**INQUIRY INTO THE APPEAL BY CASTLEFIELD INTERNATIONAL LIMITED
AGAINST REFUSAL OF RESERVED MATTERS APPLICATION BY
SOUTH CAMBRIDGESHIRE DISTRICT COUNCIL AT
LAND AT TEVERSHAM ROAD, FULBOURN**

**PROOF OF EVIDENCE OF DR ELIZABETH SOILLEUX MA MB BChir PhD
FRCPATH PGDipMedEd**

**Planning Appeal Ref: APP/W0530/W/22/3291523
Planning Application Ref: S/3290/19/RM**

Figure 3.1: Development scheme showing the areas of land which are proposed to be raised
Figure E3. New culvert, details of which are shown only in the HR Wallingford report and not on Cannon's own plans (figure E1, Appendix E).

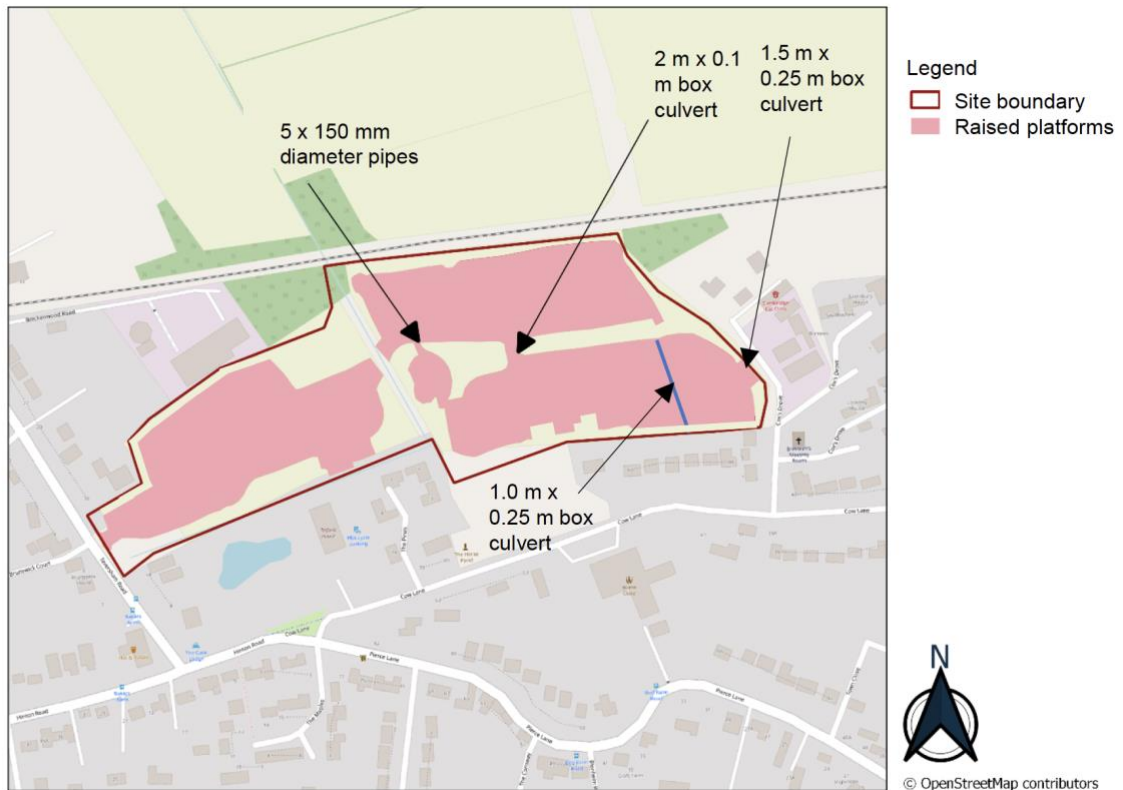
- e. The addition of a south to north culvert running approximately North North West (NNW) and emanating approximately due north of No. 50 Cow Lane and running into the Linear Park (figure E3, Appendix E)¹²¹. This is absent in the plans from the appellant on page 11 of “CCE B411 Teversham Road Fulbourn modelling and sw note 02.pdf”¹²², but present in figure 3.1 of the HR Wallingford 2022 report¹²³. Invert levels and the gradient of this are not provided.

- 100 A new culvert is proposed running from the south-eastern part of the development to Linear Park, but no invert level, slope or flow-control technologies are provided, so the likely effectiveness, probability of blockage, and risk of retrograde flow cannot be assessed (figure E3, Appendix 3)¹⁵⁰. Again, the limited information provided precludes reproduction of the appellant’s flood modelling and is contrary to the requirement of HM Planning Inspector to provide all underlying data.

Figure E5. Predicted 1 in 100 year plus climate change flooding, region along 60 Cow Lane boundary before and after development.

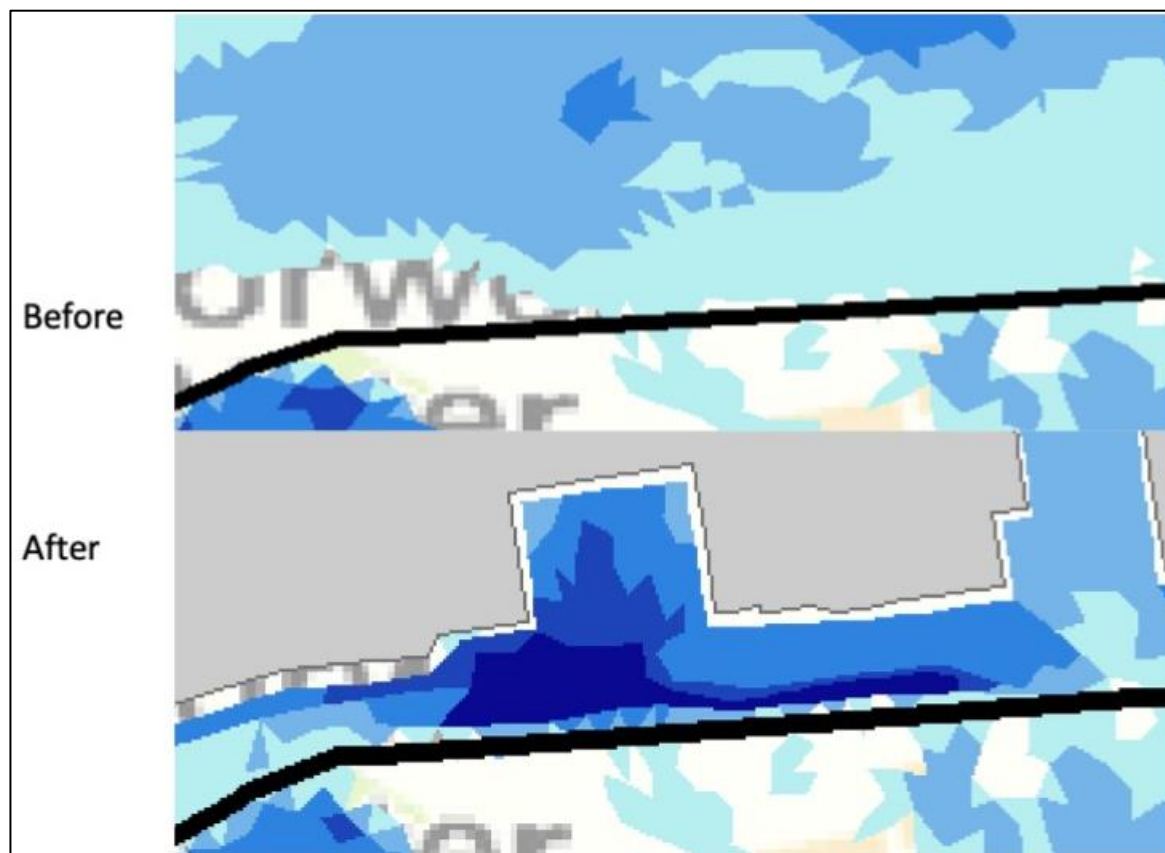
- 87 The appellant has provided diagrams in which it appears that neither the development nor surrounding properties will be subject to increased flood risk (as seen by comparing their figures 4.1 - 4.4 with figures 4.5 – 4.8 in the 2022 HR Wallingford report¹²⁹).
- 88 However, the statement in the April 2022 HR Wallingford report that there is no increased flood risk to surrounding properties conflicts with their results in, for example, their figure 4.7, reproduced here as figures E4 – E5 (Appendix E)¹³⁰. The assertion that there is no increased flood risk to surrounding properties also conflicts with page 10 of “CCE B411 Teversham Road Fulbourn modelling and sw note 02.pdf”¹³¹, on which a flood level of 9.97m is shown at the boundary, at a point which, on page 8 of is shown to be at 9.75 m (figure E6, Appendix E), using data derived from pages 9 and 10 of “CCE B411 Teversham

Figure E9. HR Wallingford was provided with topological input data (albeit incorrect data) for the western development platform, but no input data were provided for the north-eastern or south-eastern development platforms.

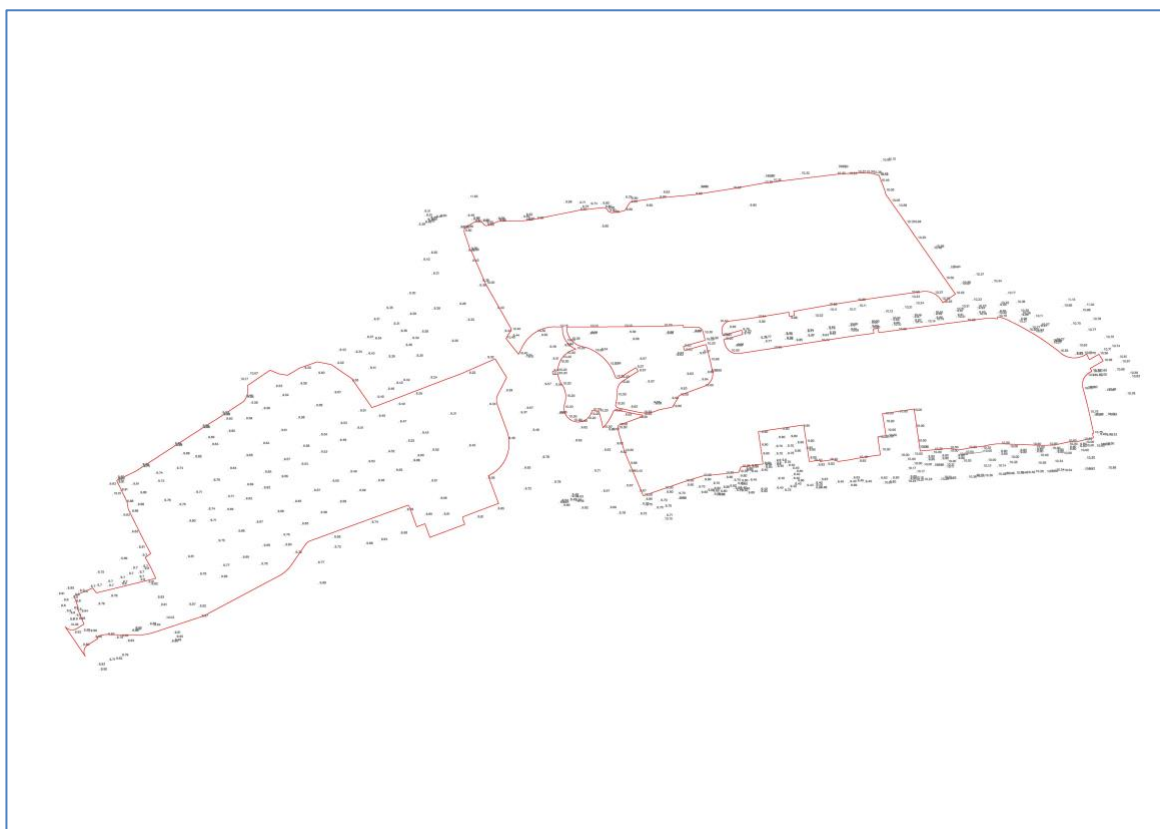
92 In “CCE B411 Teversham Road Fulbourn modelling and sw note 02.pdf”¹⁴², on page 9, topological input data for HR Wallingford’s model are given. Topological input data are provided for the western development platform, but no input data are provided for the northern or south-eastern development platforms, which appears inconsistent and makes little sense (figure E9, Appendix E).

Figure E12. Western development platform labelled as being as low as 9.22m, meaning that either houses on it will flood or HR Wallingford was given erroneous data.

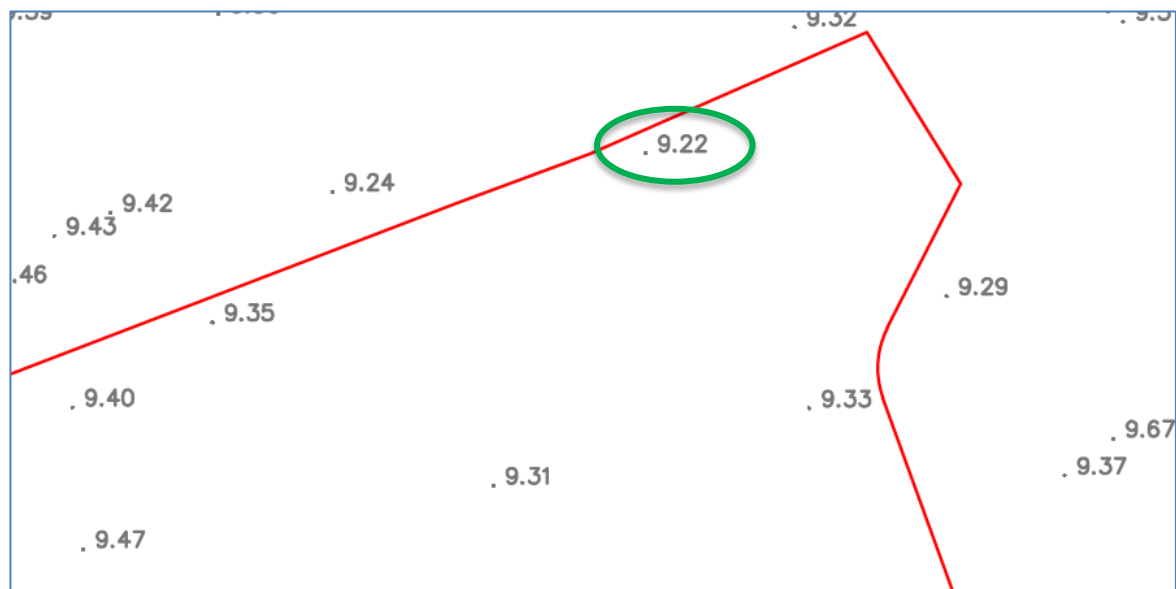
cannot have been assessed properly. Furthermore, some of the levels marked on the western development platform (figure E12, Appendix E) would be below the water table, some of the year round, as there is an area with a ground level of 9.22m, while ground water levels can be up to 9.3m (paragraph 98). It is hard to have any confidence in any of the modelling done on the basis of this input data.

Figure E18. Lowered land at the former site of the proposed Cow Lane Flood Basin indicates that this area is to be used as an infiltration basin (not permitted by the SuDS Manual²⁰, Table 13.1, p13-5, due to high ground water level).

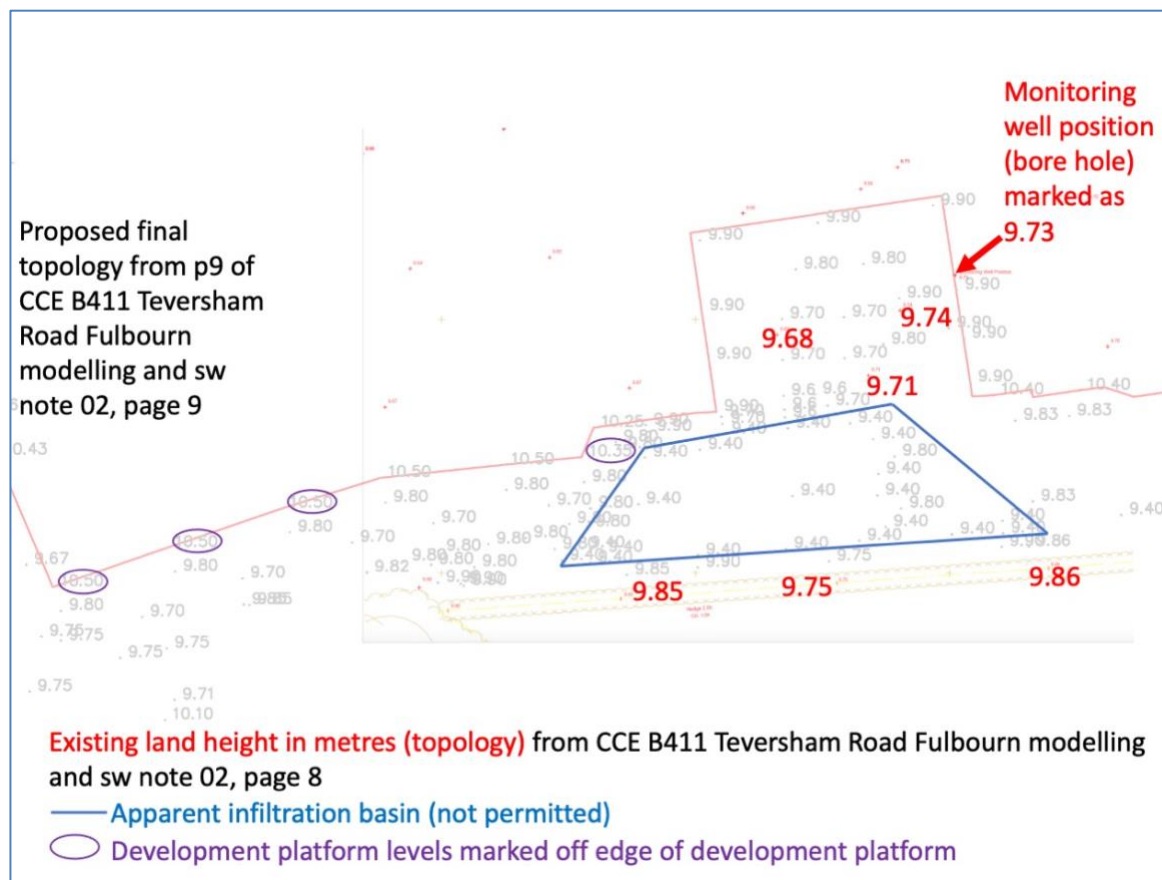
and evaporation (in a British climate) has reappeared. As the land height at the nearby bore hole (water measurement well) WS1a is given as 9.73m on page 8 of “CCE B411 Teversham Road Fulbourn modelling and sw note 02.pdf”¹⁴⁸, and our highest water table reading is 43 cm or 0.43m (figure C11, Appendix C), this indicates that water table is at 9.30m, at least some of the time, making it only 10 cm (0.1m) below the 9.4 m base of this clandestine infiltration basin.
